**SUNDRY NOTICES AND REPORTS ON WELLS** FEB 26 2018  
Do not use this form for proposals to drill or to re-enter an abandoned well. Use form 3160-3 (APD) for such proposals.

1. Type of Well <input type="checkbox"/> Oil Well <input type="checkbox"/> Gas Well <input checked="" type="checkbox"/> Other: INJECTION	8. Well Name and No. POKER LAKE UNIT 098
2. Name of Operator BOPCO LP Contact: TRACIE J CHERRY E-Mail: tjcherry@basspet.com	9. API Well No. 30-015-27962
3a. Address P O BOX 2760 MIDLAND, TX 79702	10. Field and Pool or Exploratory Area SWD; DELAWARE
3b. Phone No. (include area code) Ph: 432-683-2277	11. County or Parish, State EDDY COUNTY, NM
4. Location of Well (Footage, Sec., T., R., M., or Survey Description) Sec 30 T24S R31E Mer NMP SWNW 1980FNL 660FWL

BOPCO, LP respectfully submits this sundry notice of intent to plug and abandon the referenced well.

# Poker Lake Unit #98 Current and Proposed WBD's

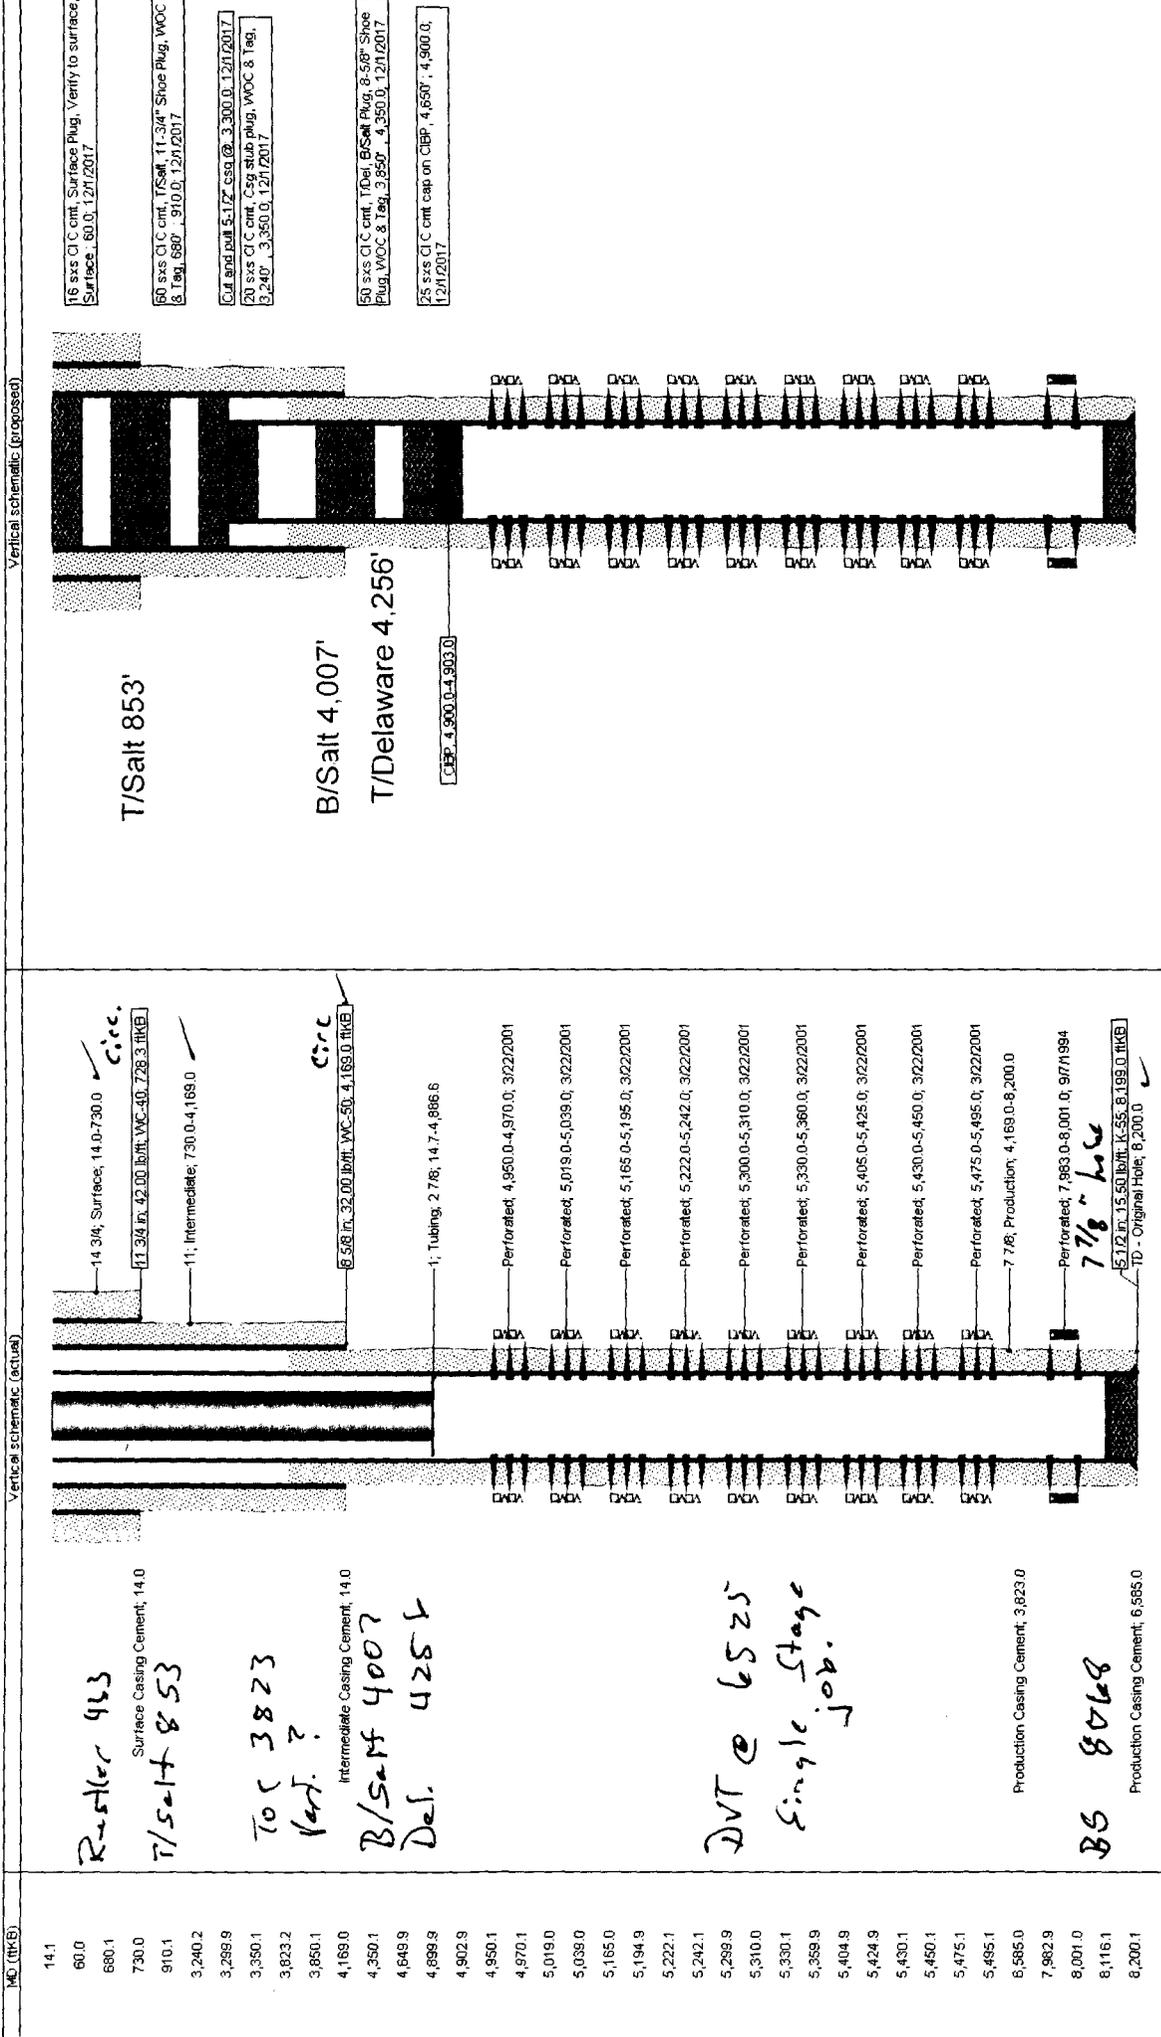
Perf @ 4350, attempt to 5g2 cmt to 3850. IF no 5g2 drop to 4400

Spot cmt. to 3850.

5. ~~RH with jet cutter for 5 1/2" 15.5# casing. Cut casing at 3,300?. Circulate 9.5# salt gel to from 3,300? to surface. Pull and LD 5-1/2" casing.~~

6. ~~RH with tubing to 3,350', spot 20 sxs Class C cmt 3,350' - 3,240'. WOC and tag (Csg Stub plug).~~

7. PUH to 910', spot 60 sxs Class C cmt from 910? to 680?. WOC and tag (T/Salt, 11-3/4" shoe plug).  
*Perf @ 910 SQZ cmt to 680.*

8. PUH to 60', spot 46 sxs Class C cmt from 60' to surface. Verify to surface (Surface plug).  
*Perf @ 60' SQZ. cmt salt*
